Subject: SQUEAKING NOISE FROM REAR OF VEHICLE WHEN DRIVING ON BUMPY ROADS AND TURNING	Bulletin No.: 02-004/23
	Last Issued : 11/08/2023

2024 CX-90

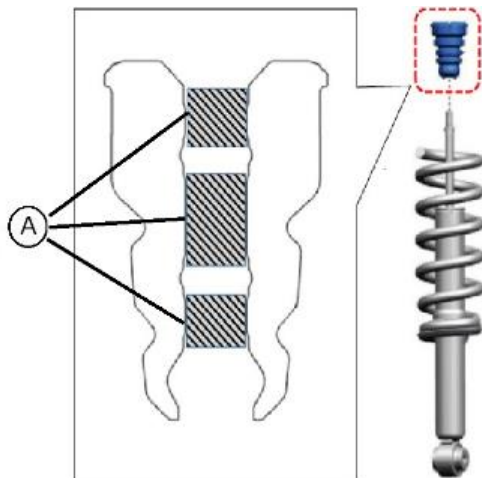
Some customers may complain about squeaking noise coming from the rear of vehicle when driving on bumpy roads and turning. This is caused when the lubricant coating comes out of the bump stopper, changing the resistance between the damper rod and bump stopper. To eliminate this concern, a mass production change is under study. Customers having this concern should have their vehicle repaired using the following repair procedure.

1. Verify the customer concern.
2. Remove both rear bump stoppers according to the instructions in MGSSI (REAR SHOCK ABSORBER AND COIL SPRING REMOVAL/INSTALLATION) and (REAR SHOCK ABSORBER AND COIL SPRING DISASSEMBLY/ASSEMBLY).
3. Apply rubber grease (0.5-1.0g) inside the bump stopper, principally at the areas indicated in the image below (A).
